Hornsea Project Four

Applicant's comments on other submissions
received at Deadline 6

Deadline 7, Date: 10 August 2022

Document Reference: G7.2

Figure 1: Version of figure 23 that was included in the RIAA as part of the DCO Application (APP-167)

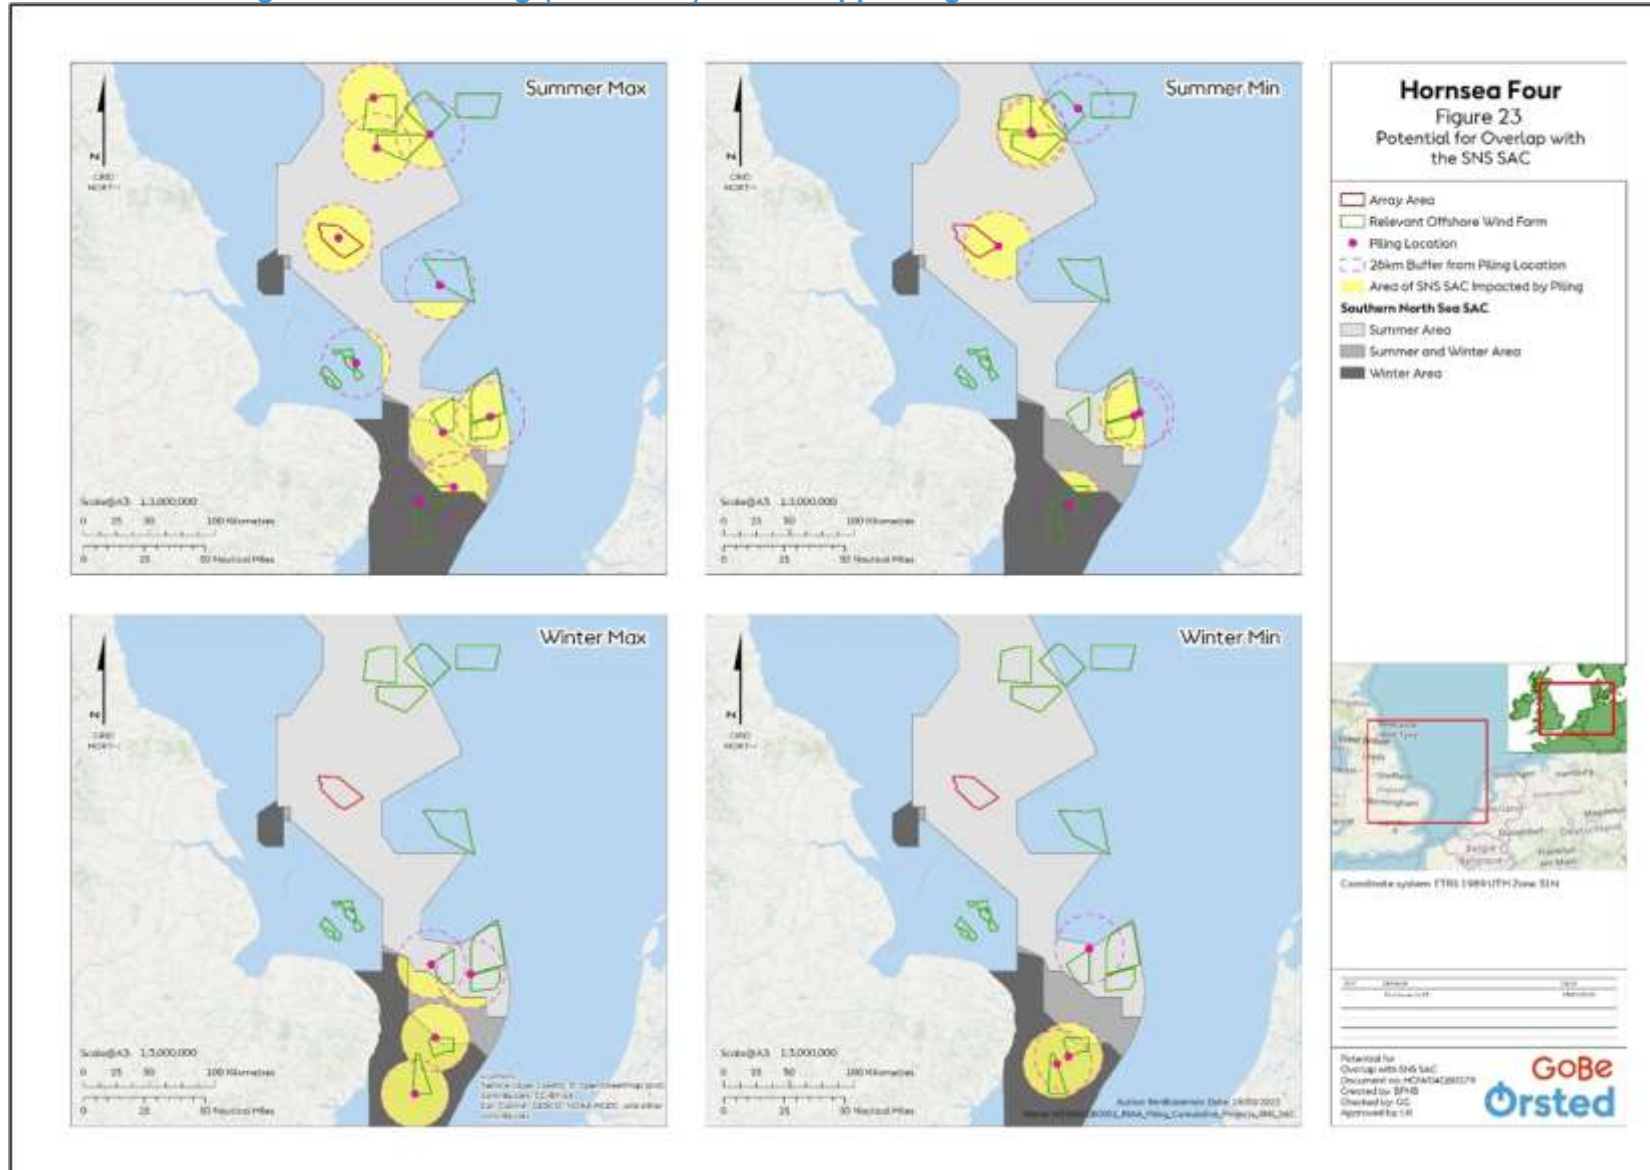
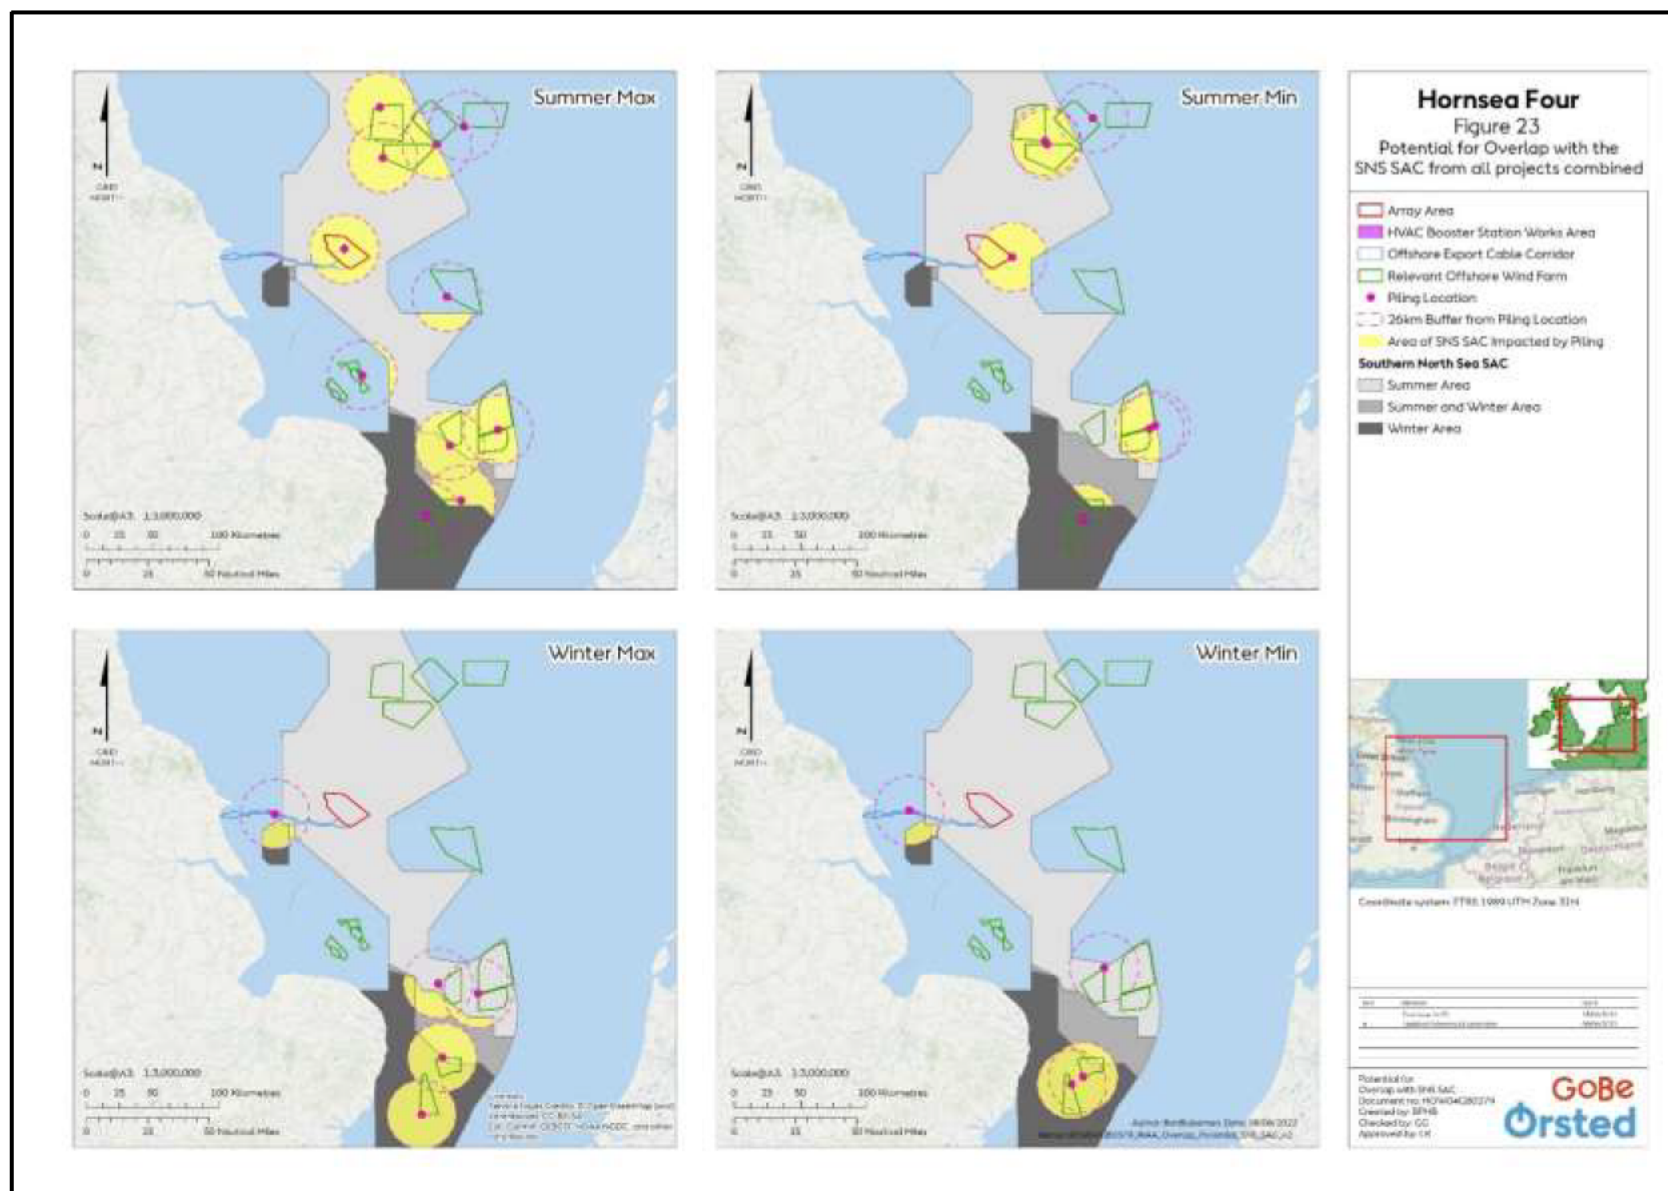
Reference	Stakeholder's Written Representation	Applicant's Response
	<p>- the contribution of Dogger Bank C to in-combination disturbance in the summer max scenario</p>	<p>For clarity, the Applicant has copied the version of Figure 23 included in the RIAA as part of the DCO Application (APP-167) (Appendix A, Error! Reference source not found.), followed by the updated version of Figure 23 submitted at Deadline 5 (REP5-012) Appendix A, (Error! Reference source not found.). The changes can be summarised as the inclusion of a buffer around a piling location at Dogger Bank C in the Summer Max frame (which does not overlap with the Southern North Sea Special Area of Conservation (SNS SAC), and the inclusion of a buffer around a piling location within the HVAC booster station works area for Hornsea Four in the Winter Max and Winter Min frames. The Applicant considers that these changes address the comments raised by Natural England and as such, the Applicant considers this action closed.</p>

Figure 2: Updated version of Figure 23 that was included in the Deadline 5 submission of the RIAA (REP5-012).
